# The Cleveland-Cliffs Iron Company PDR

March 21, 1980

Re: Source Materials License No. SUA-1352, Docket No. 40-8714

FIGURE MP-4.1

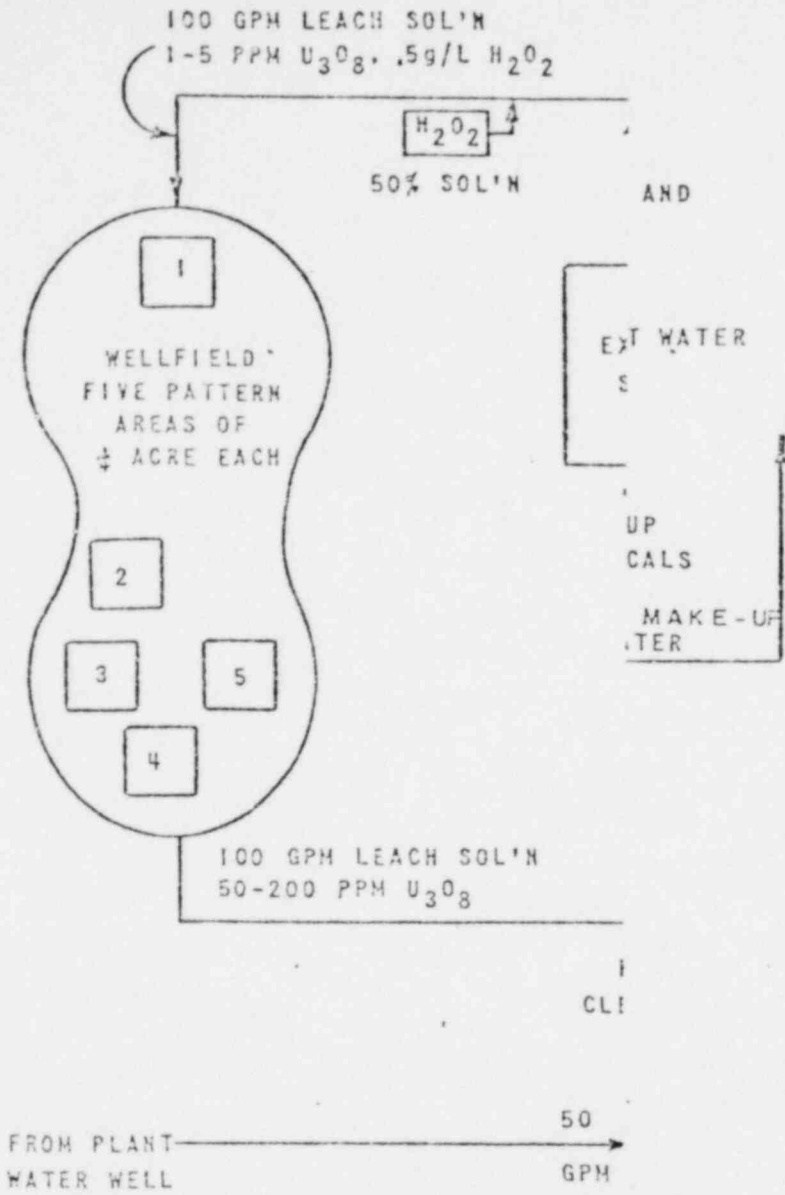
- 2.0, par. 1, p.3: A revised Site Plan is attached.
- 2.1, par. 1, p. 3: The total permit area is approximately 42.5 acres (17.2 hectares) and direct surface disturbance is approximately 19.7 acres (8.0 hectares).
- 3.0, par. 1, p. 35: A revised Uranium Recovery Process Schematic is attached.
- 3.1.1, par. 6, p. 39: Bladder storage will be used as required.
- 3.1.3, par. 7, p. 41: Monitor wells labeled 230, 237, 238, 239, 240, and 241 are shown on the Site Plan.
